Banning Unified School District

**Request for Proposals (RFP) #27-001
For an Energy Conservation/Public Works Project under Government Code
§4217**

Transportation Yard Solar, Storage, and VGI Demonstration

**ADDENDUM #2 – PROJECT SCOPE CHANGES AND
CLARIFICATIONS**

Conceptual Site Plan

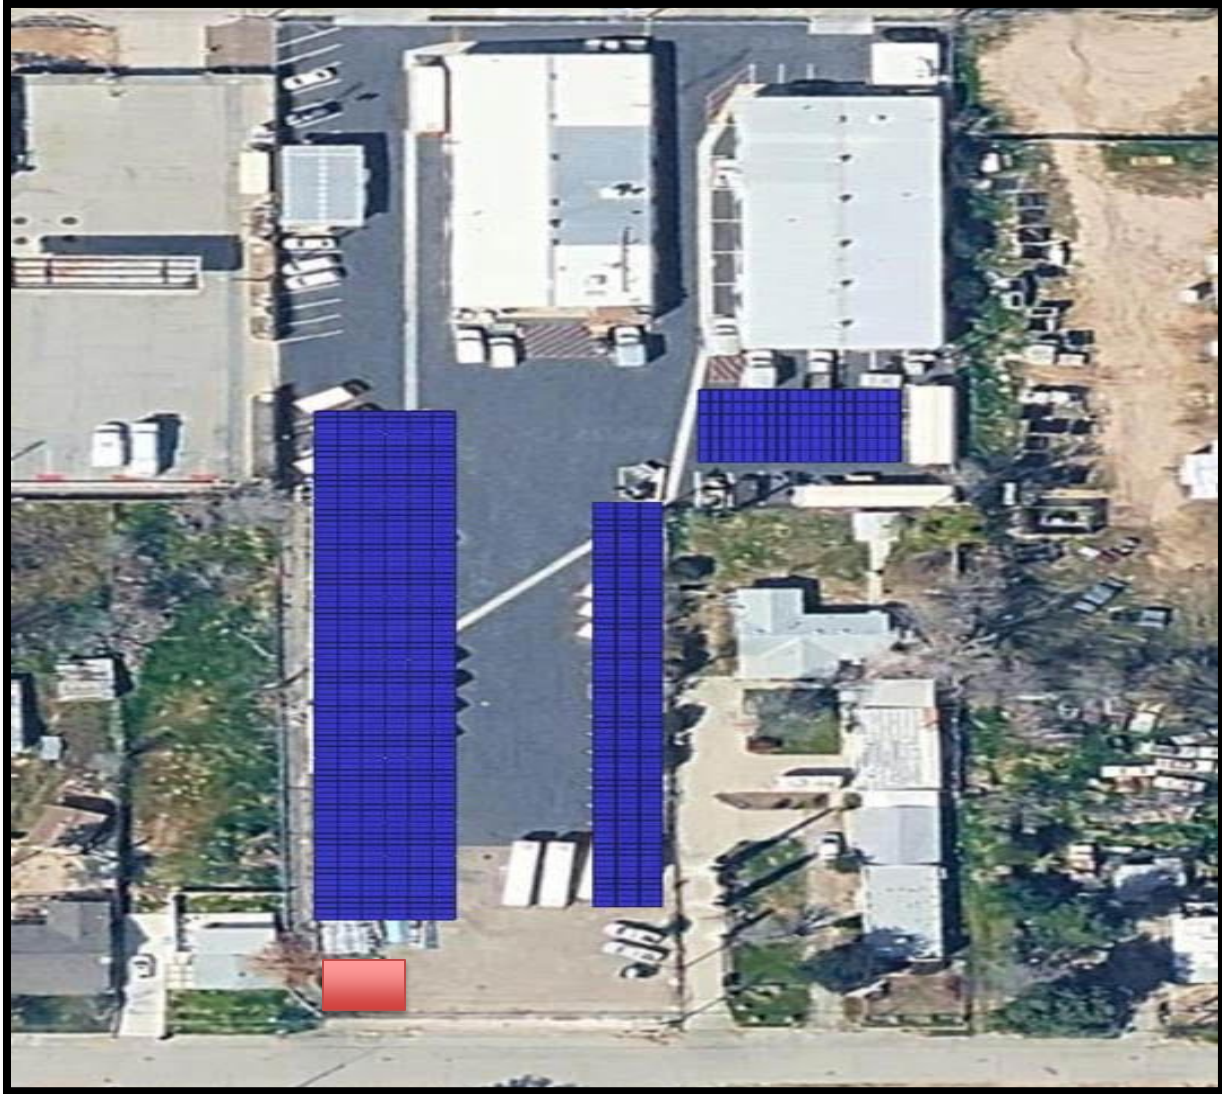
As such, the solar capacity will now be 400 kW (instead of 300 kW specified in the RFP) and 1,000 kW/2,000 kWh of energy storage.

Three Solar Arrays: The aerial image below shows how this capacity will be added. THERE WILL BE NO ROOFTOP SOLAR. Instead, a new T structure array is planned in the northeast part of the bus parking lot. The large T structure array on the west side will be elongated as will the single cantilever structure spanning the south east portion of the lot. Proposers shall incorporate the three identified array areas into their proposed design, subject to final engineering, code requirements, site conditions, utility coordination, and District approval.

Tilt Angles: Both of the long arrays will tilt at 5 degrees to the west. The new, added array in the northeast corner will tilt south at 5 degrees.

BESS Location: The District's preferred BESS location is the southwest corner of the site, as conceptually depicted. Final location shall be subject to applicable code requirements, final design, AHJ approval, utility coordination, and District approval.
